Detailed Site Plan 7-Eleven Branch Avenue

DSP-19031

STAFF REPORT

SUBJECT: Detailed Site Plan DSP-19031
Type 2 Tree Conservation Plan TCP2-026-2018-01
7-Eleven Branch Avenue

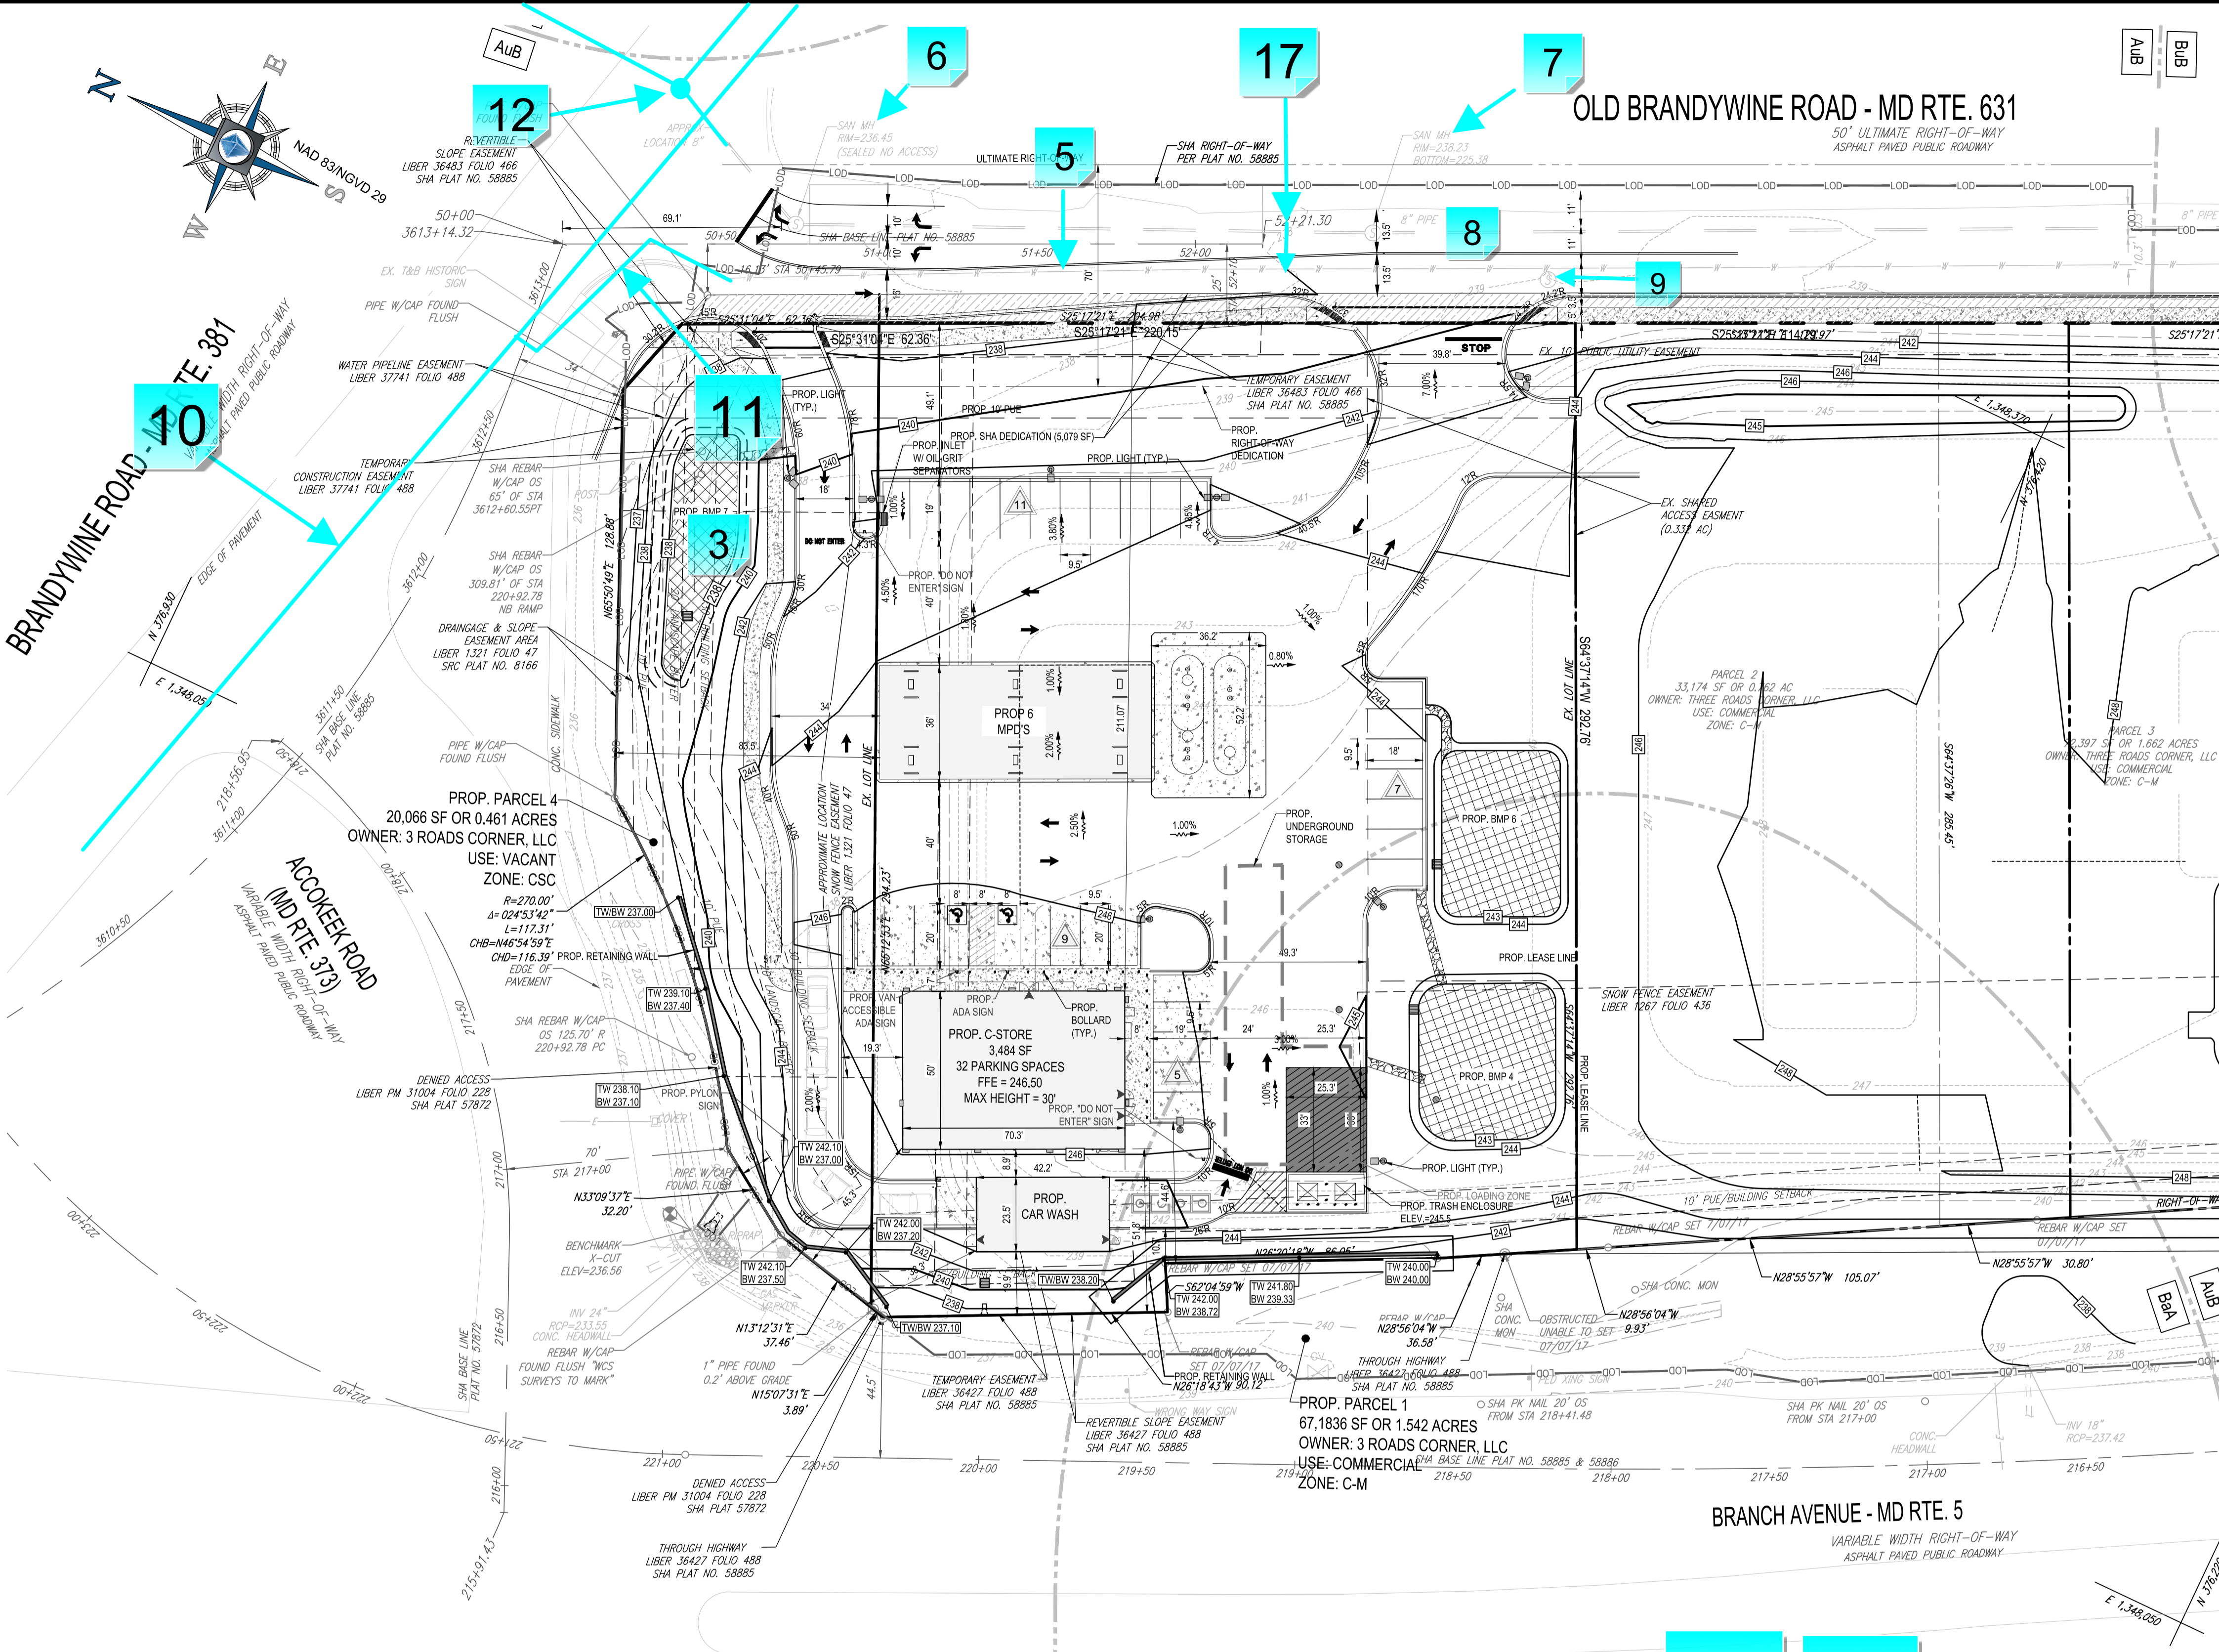
As discussed at SDRC last week, attached is the Updated Site Plan sheet to address comments from Trails. Specifically I have broken out the particular changes we have incorporated in a few bullet points below. **We will resubmit the full package by 6/25 noon.**

- Sidewalk connection has been added from the proposed sidewalk on-site to the existing sidewalk along Accokeek Rd
- Crosswalk has been added from proposed sidewalk onsite along the northwest side of the site across the carwash entrance to the building
- Proposed sidewalk and associated crosswalks has been added from the Second entrance along Old Brandywine Road to the sidewalk at the building
